September 7, 2010

Re: FINAL ENVIRONMENTAL IMPACT STATEMENT AND PROPOSED
AMENDMENT TO THE CALIFORNIA DESERT CONSERVATION AREA
PLAN FOR THE CALICO SOLAR (FORMERLY SES SOLAR ONE)
PROJECT, SAN BERNARDINO COUNTY, CALIFORNIA

**Re: Comments on Final Environmental Impact Statement
and Protests to Proposed Grant of Right-of Way to
Calico Solar LLC under the FLPMA and to Amendment
of the California Desert Conservation Area Plan**

Figure 1. Measurement/model positions on Maricopa Solar siteplan (NTS)

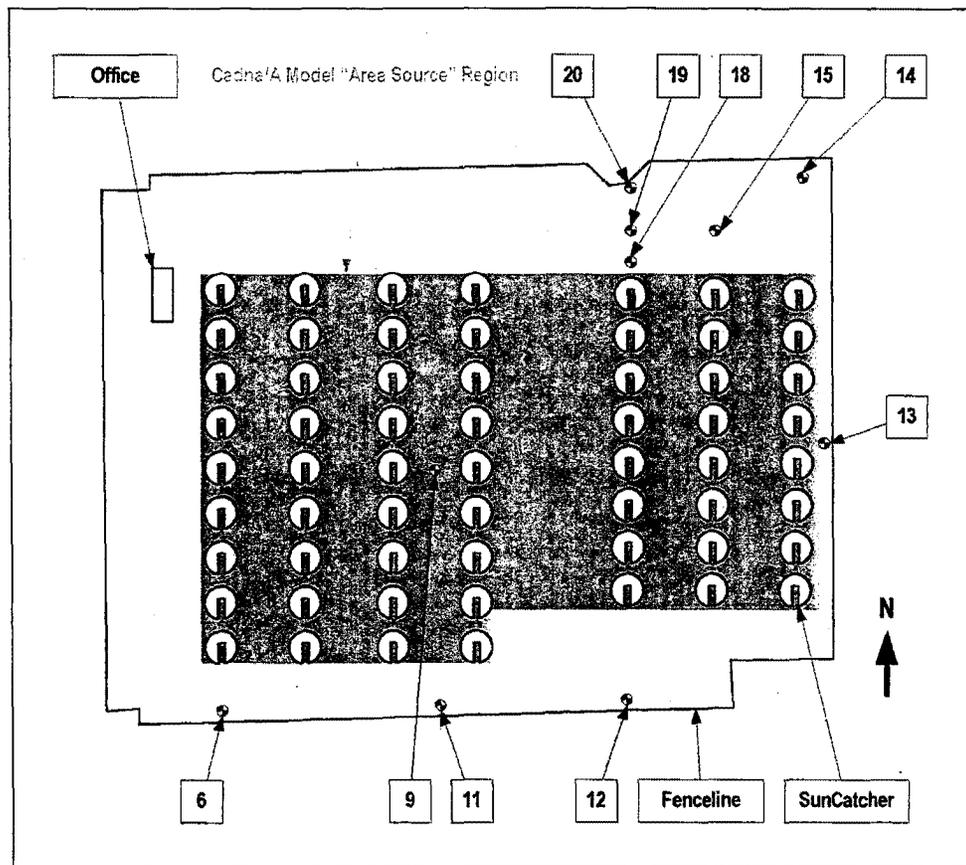
Measurement and predictive model locations that are referenced in Table ES-1 appear as numbered callouts in Figure 1, which depicts a simplified Maricopa Solar site plan and its major features. Representative photographs of these measurement locations appear in Appendix A, attached to this technical memo. Not shown are the following features and sources of non-project ambient noise that adjoin the site:
